Product Change Notification / DSNO-09TPSA420

eSign# SPE0000007 Final Notice: Release of updated software version of Synplify Pro Microchip Edition v2023.09M-1 & Synplify Pro Standalone v2023.09-1 for various FPGA devices.

Figure 2: Incorrectly Mapped Netlist Schematic showing Missing d1[1] Connection

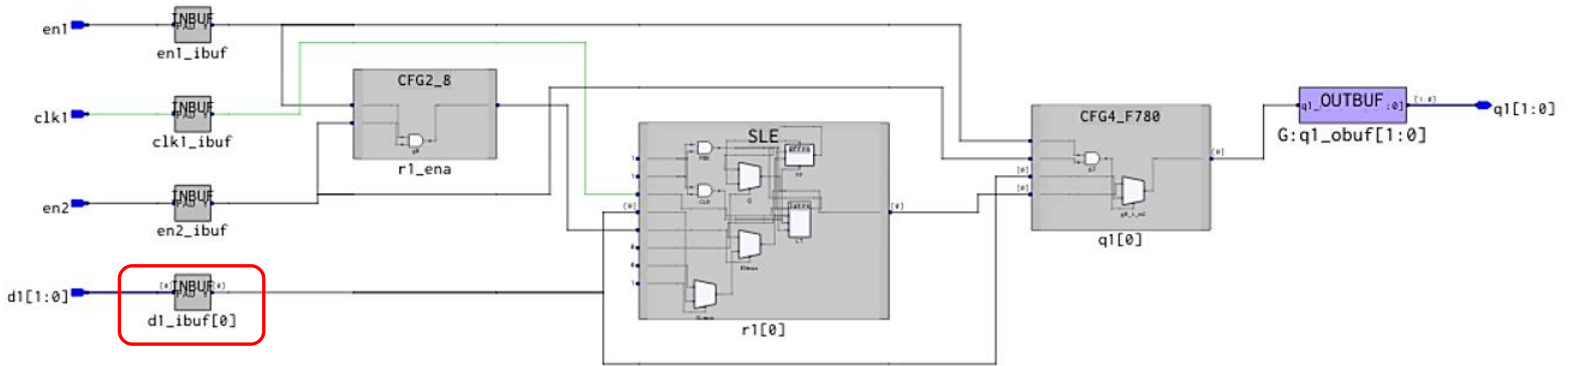
Due to the issue present in Synplify Pro standalone all-vendor versions 2023.03 and 2023.09, as well as Microchip Edition version 2023.09M, the mapped netlist incorrectly left the d1[1] pin unconnected. After technology mapping, the Most Significant Bit (MSB) d1[1] of port d1[1:0] was lost and only d1[0] was preserved in the mapped schematic view below:

Figure 3: Correctly Mapped Netlist Schematic using Synplify Pro v2023.09M-1 Software

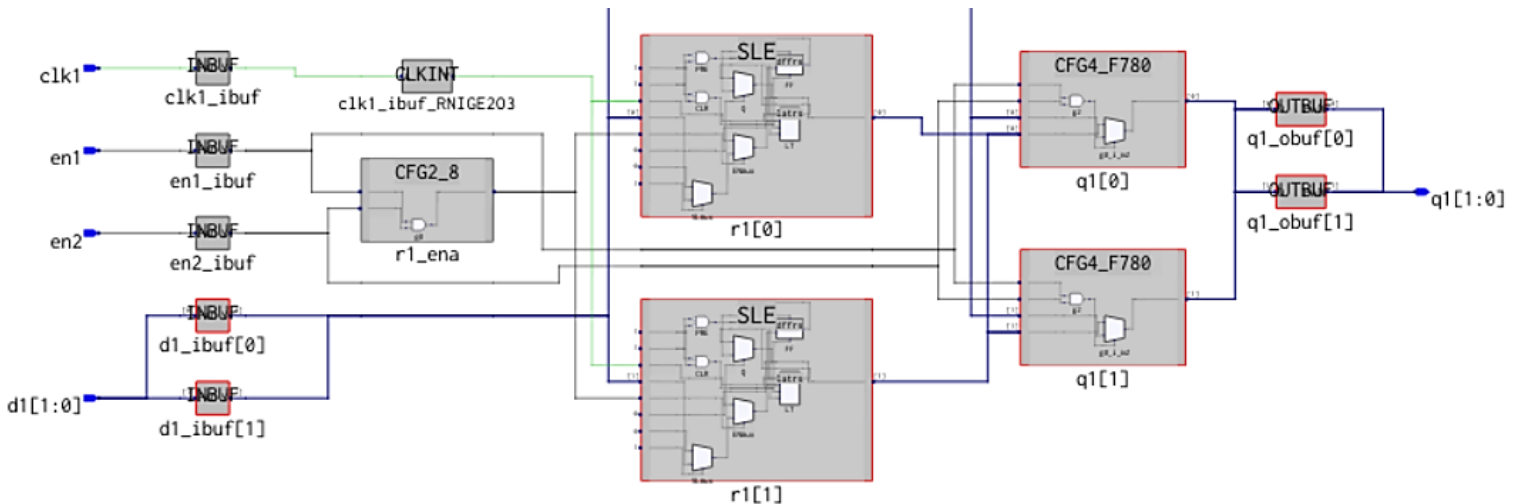
In contrast, when synthesized with Synplify Pro v2023.09M-1 software containing the fix for this issue, both bits d1[1] and d1[0] are driving the logic, and MSB d1[1] is no longer dropped, as shown in the figure below.
